SERVICE BULLETIN

DATE: 28 MAY 1993

PILOT PREFLIGHT CHECK OF YSAS ACTUATOR AND REPLACEMENT OF S.A.S. ACTUATOR

Figure 1. Rework of Static Port Intake.

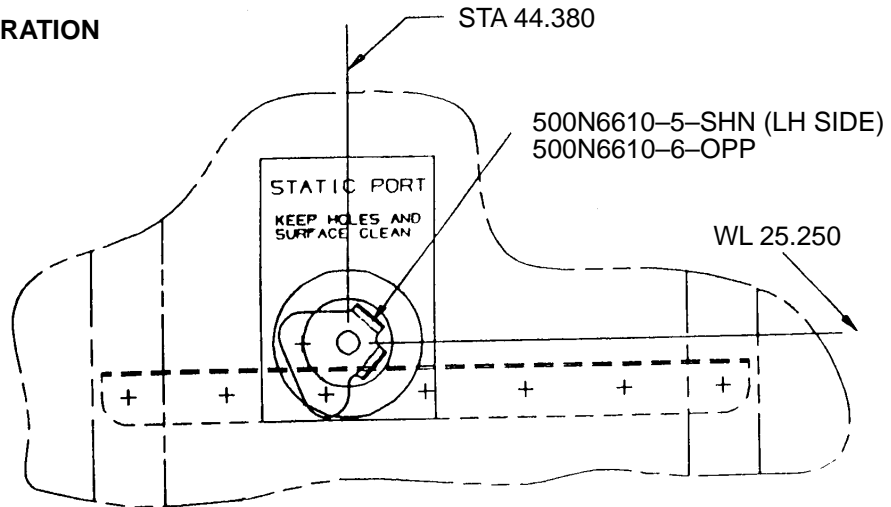
NEW CONFIGURATION

OLD CONFIGURATION
